Addendum 1

Project: BID NO. 9953 TROY SCHOOL DISTRICT 2023 PAVING PROGRAM

PROJECT: 2023 Troy School District Site Improvements – Paving Projects

PURPOSE: Addendum 1

BARNARD ELEMENTARY SCHOOL 3601 FORGE RD. TROY,MI

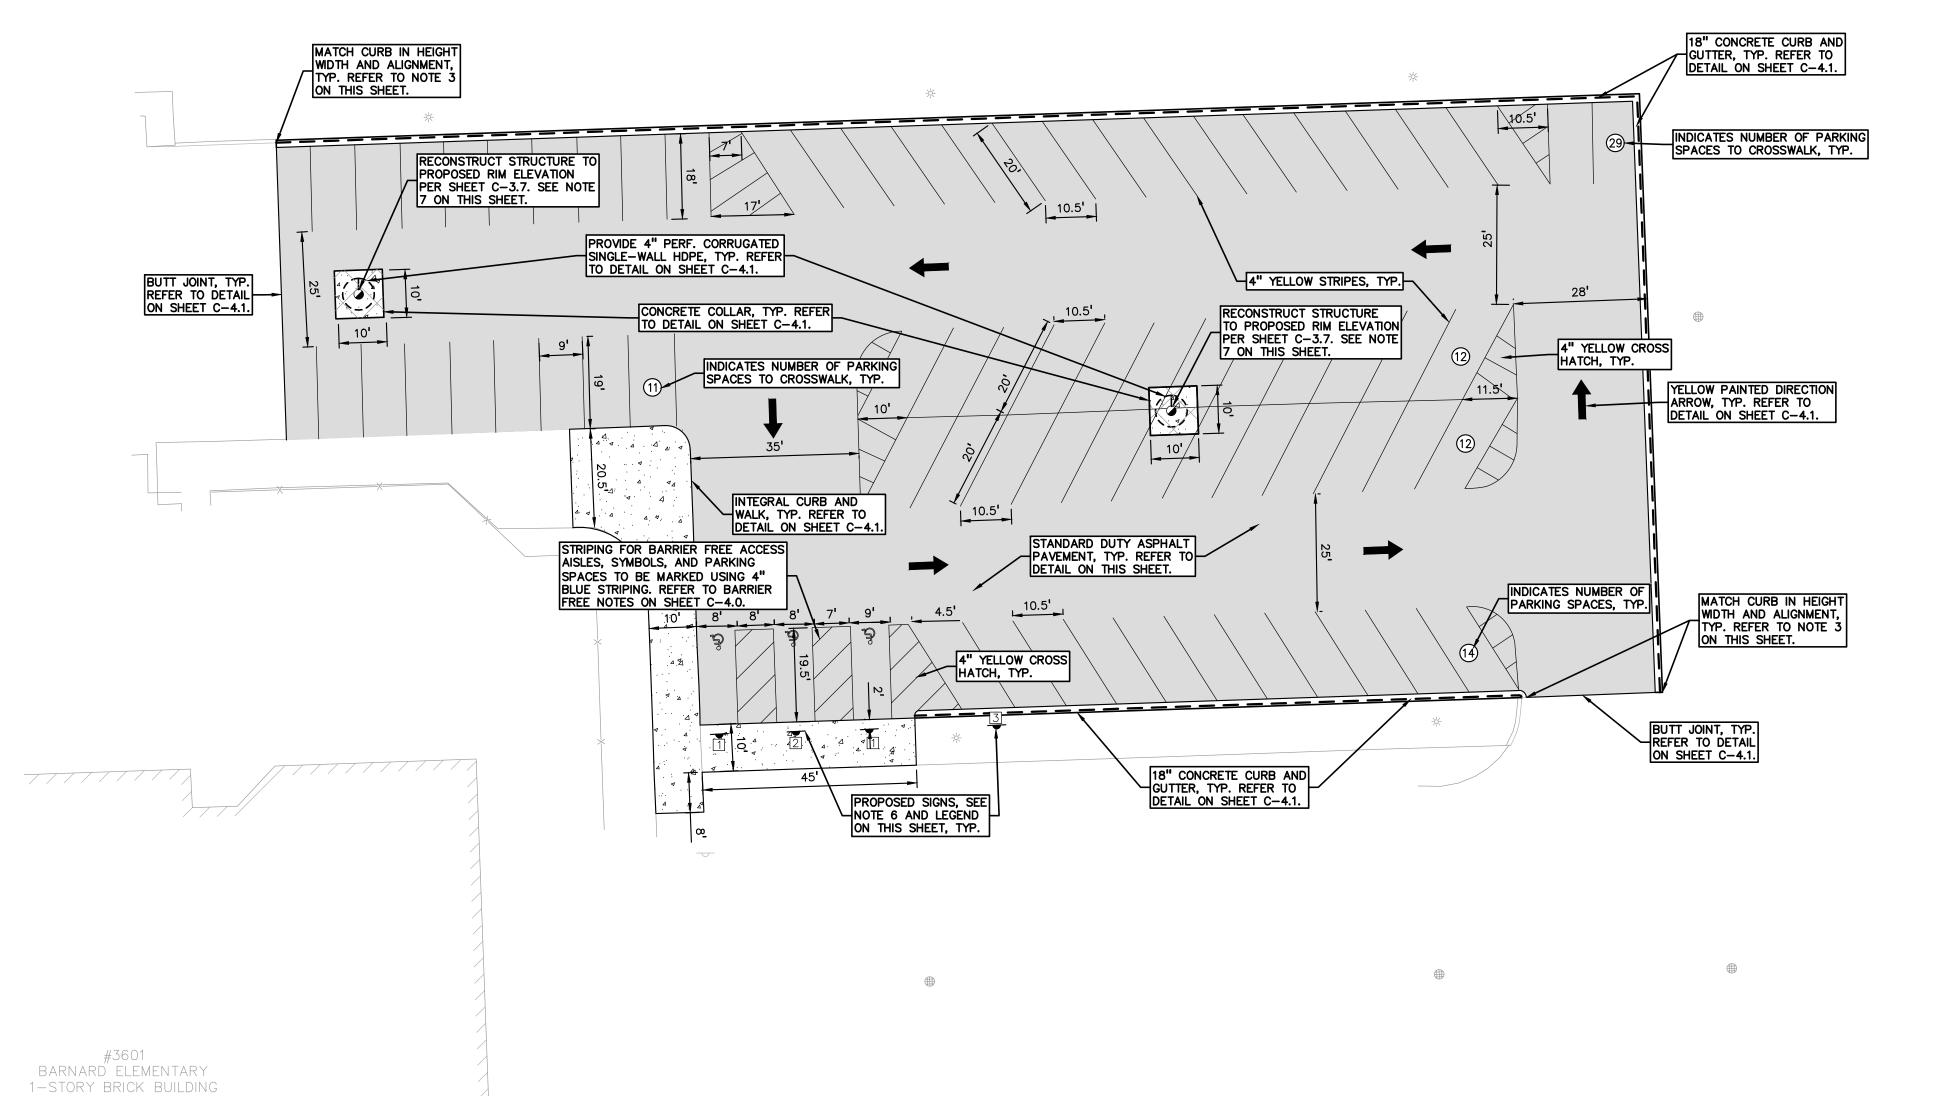
- a. Sheet C-2.7
 - 1. The "Subgrade Undercutting Notes" were updated to provide additional clarification.

- TO MINIMIZE SUBGRADE INSTABILITY AND UNDERCUTS, THE SUBGRADE SHALL NOT BE LEFT EXPOSED TO PRECIPITATION AND CONSTRUCTION OPERATIONS AND SHOULD BE PERFORMED DURING THE SUMMER MONTHS TO ENSURE DRY, WARM, WEATHER. ADDITIONALLY, THE SUBGRADE MAY BECOME UNSTABLE UNDER REPEATED LOADING OF CONSTRUCTION TRAFFIC; THEREFORE, CONSTRUCTION EQUIPMENT SHOULD BE LIMITED ON THE EXPOSED SUBGRADE.

- SUBGRADE UNDERCUT SHALL BE EVALUATED BY A QUALIFIED ENGINEERING TECHNICIAN TO DETERMINE IF SUBGRADE STABILIZATION IS NECESSARY. UNDERCUT EXCAVATIONS SHALL BE BACKFILLED WITH MDOT 21AA DENSE GRADED AGGREGATE PLACED IN AN ENGINEERED MANNER. LIFT THICKNESS SHALL NOT EXCEED 9 INCHES. THE USE OF TRI-AXIAL GEOGRID MAY BE USED TO REDUCE UNDERCUT DEPTHS, AS APPROVED BY THE DISTRICT AND PER THE UNIT PRICE PROVIDED WITH THE CONTRACTORS BID.

- THE QUANTITY FOR "SUBGRADE UNDERCUT" FOR EACH SITE SHALL BE INCLUDED IN THE BASE BID. THIS ITEM IS CONSIDERED AN ALLOWANCE AND FINAL PAYMENT WILL BE BASED ON THE ACTUAL VOLUME OF COMPACTED IN PLACE STONE PER THE UNIT PRICE PROVIDED IN THE BID PACKAGE.

- ALL ENGINEERED FILL SHALL BE COMPACTED TO A DENSITY OF AT LEAST 95 PERCENT OF THE MAXIMUM DENSITY DETERMINED BY THE MODIFIED PROCTOR (ASTM D1557) METHOD OF TESTING. ALL ENGINEERED FILL MATERIAL SHALL BE PLACED AND COMPACTED AT APPROXIMATELY THE OPTIMUM MOIUSTURE CONTENT, FROZEN MATERIAL SHALL NOT BE USED AS FILL, NOR SHOULD FILL BE PLACED ON A FROZEN SUBGRADE.

- SUBGRADE UNDERCUT DRAIN TILE SHALL BE EVALUATED BY A QUALIFIED ENGINEERING TECHNICIAN TO DETERMINE IF SUBGRADE STABILIZATION IS NECESSARY. DRAIN TILE SHALL BE PLACED WITHIN ANY UNDERCUT AREA AND CONNECTED TO THE CLOSEST CATCH BASIN TO PREVENT GROUNDWATER FROM POOLING WITHIN THE GRANULAR SOILS IN UNDERCUTS AND CREATING "BATHTUBS" IN THE COHESIVE SOILS.

- THE QUANTITY FOR 'SUBGRADE UNDERCUT DRAIN TILE (4")" FOR EACH SITE SHALL BE INCLUDED IN THE BASE BID. THIS ITEM IS CONSIDERED AN ALLOWANCE AND FINAL PAYMENT WILL BE BASED ON THE ACTUAL FOOTAGE OF COMPACTED IN PLACE STONE PER THE UNIT PRICE PROVIDED IN THE BID PACKAGE.

C-3.2

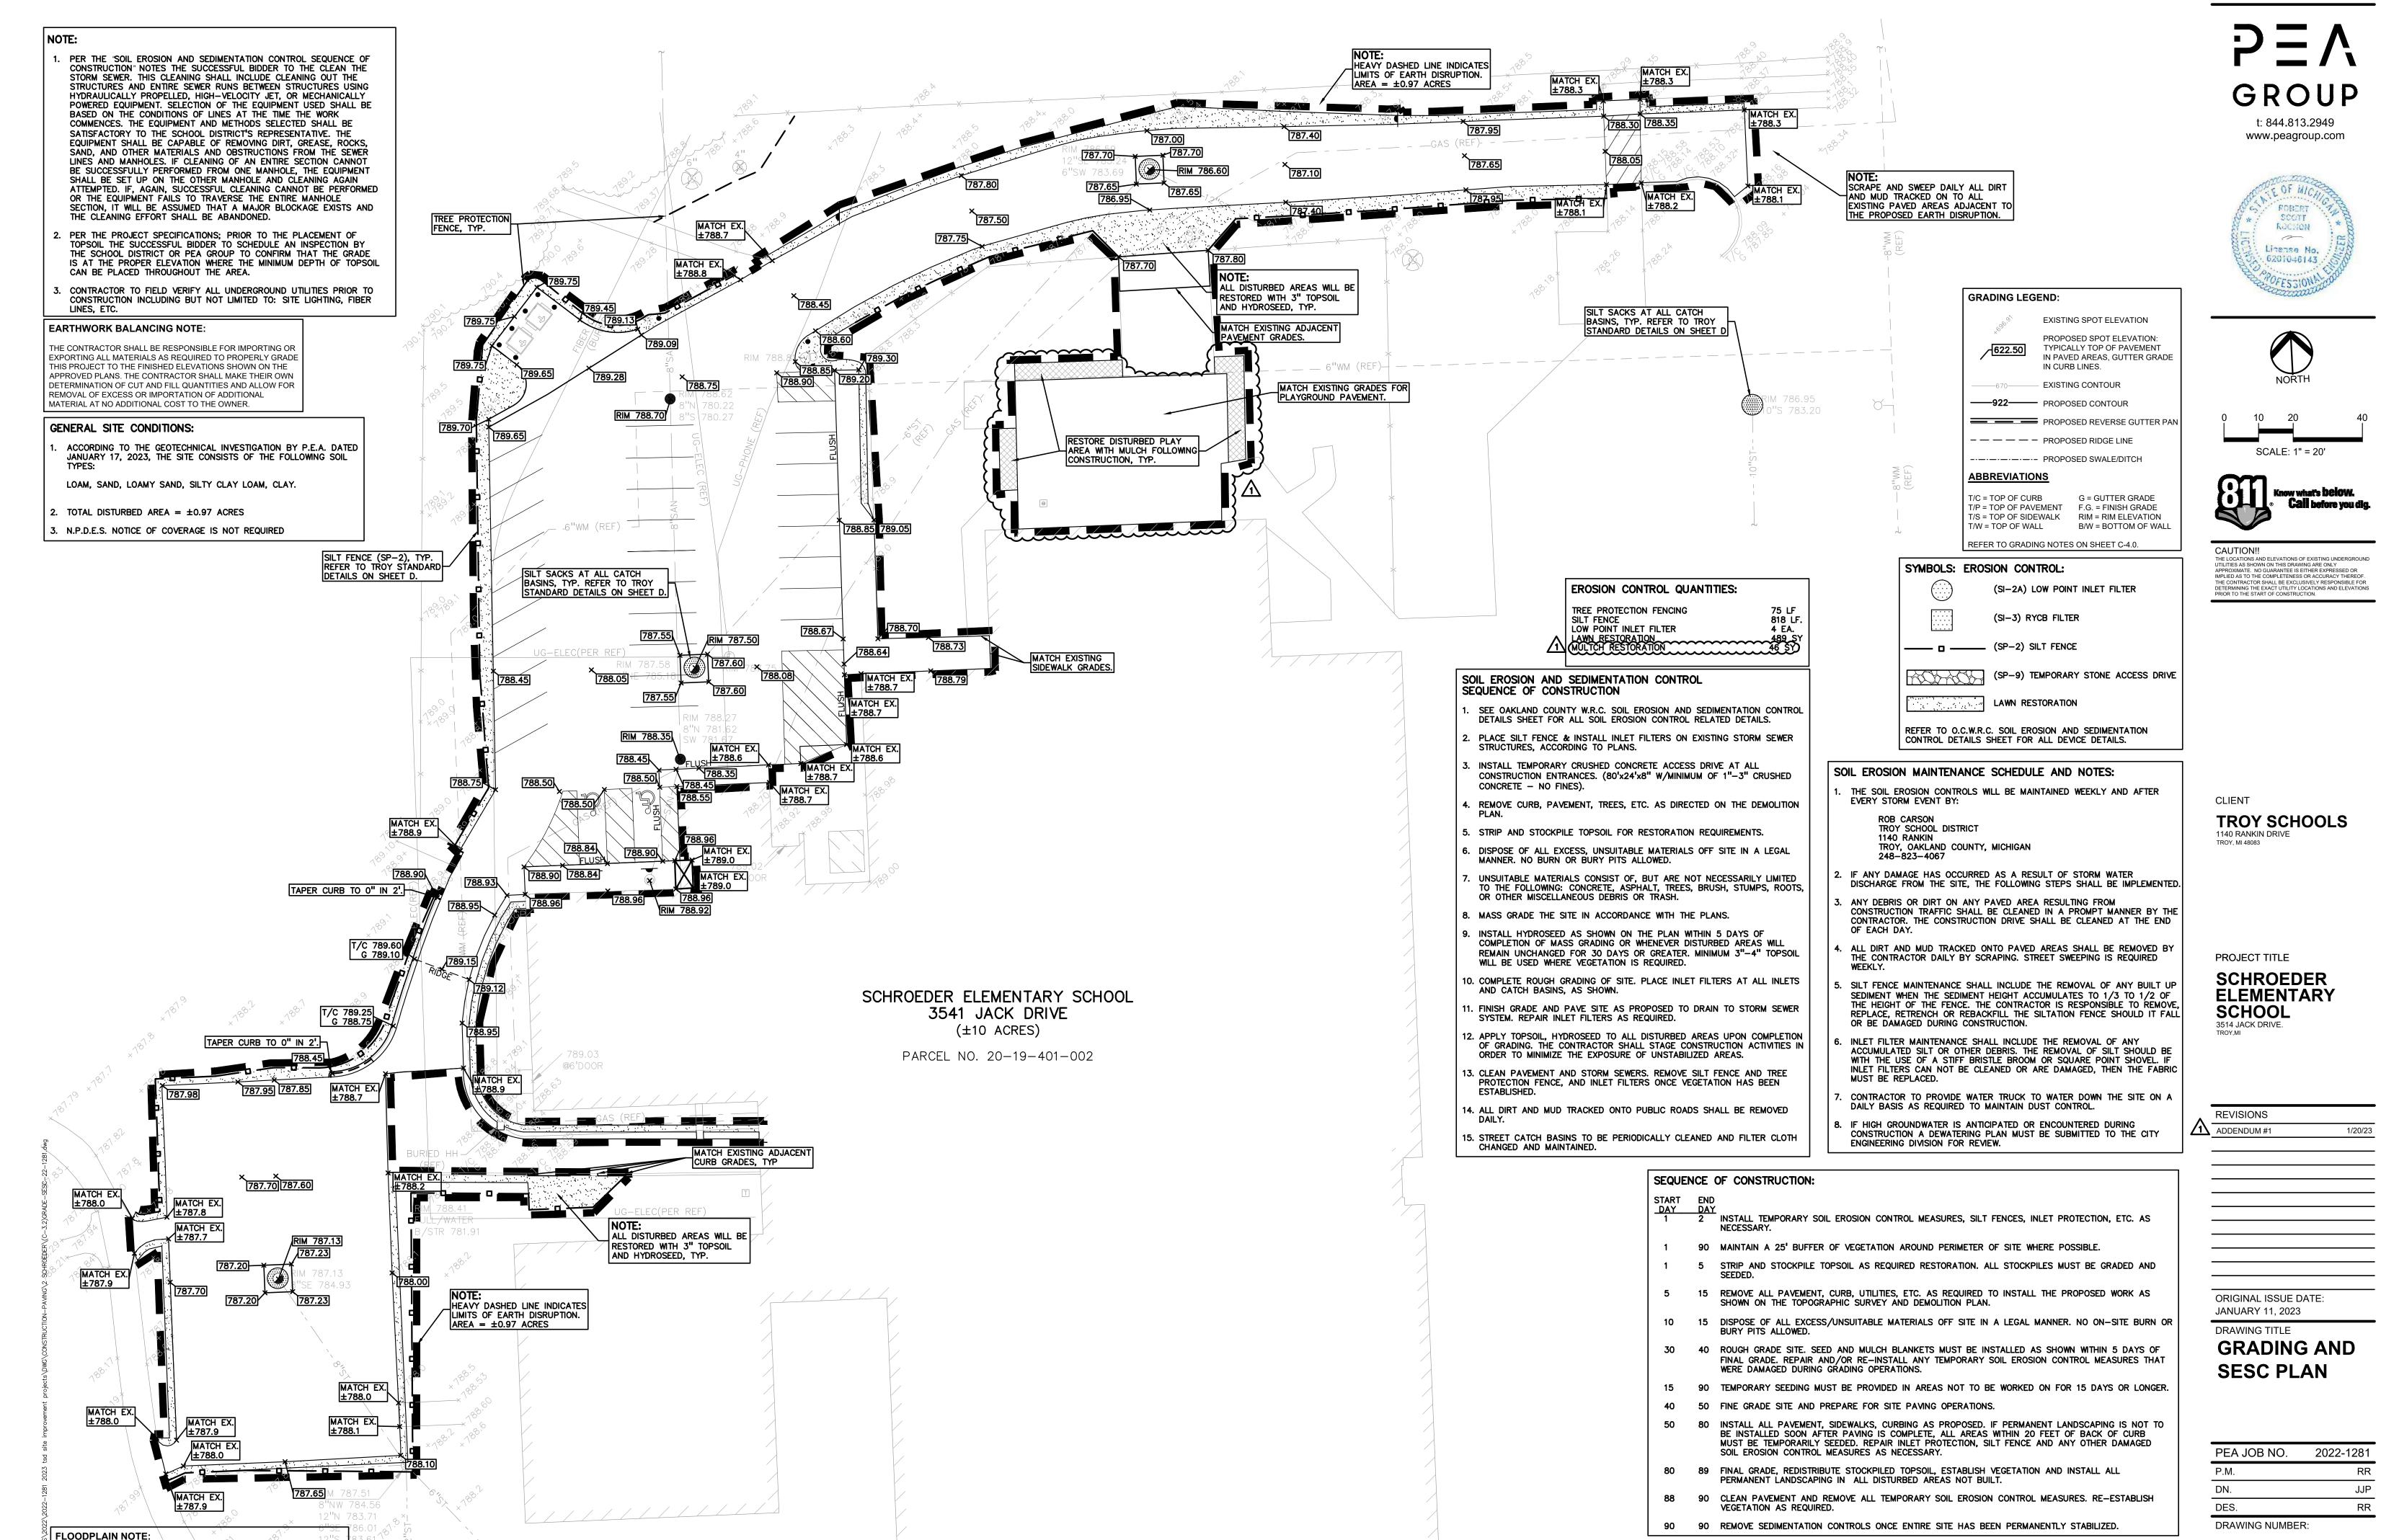
c. Sheet C-3.2

1. Areas of woodchip restoration and a quantity were added to the plan sheet for clarification.
